Addendum # 1

RFP No. JC-2663-599415

(April 22, 2005)

Addendum 1, Figure 1: Approximate Gantry Layout

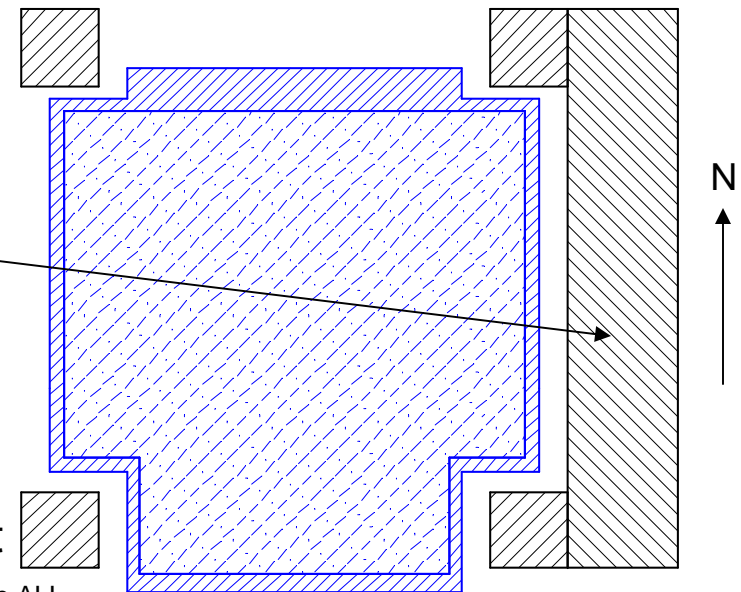
- 1 The VTTP site is prepared such that the foundation is complete with all negotiated interfaces ready for installation of the VTTP. No other TDT structures are in place. Figure 2 illustrates the approximate site layout. Note that in this scenario none of the other structures will be present at the time of VTTP assembly.
- 2 The VTTP site is prepared such that the foundation is complete with all negotiated interfaces ready for installation of the VTTP. The gantry structure including stair tower, control booth and bridge crane are installed onto the foundation prior to VTTP installation. Note: the 5 ton bridge crane will not be available for VTTP assembly usage except under limited, negotiated circumstances. Figures 1, 2 and 3 illustrate the approximate gantry configuration and site layout.

Approximate gantry configuration to be used in planning the on site assembly activities: Note ALL dimensions are approximate and subject to change, overall configuration will remain constant.
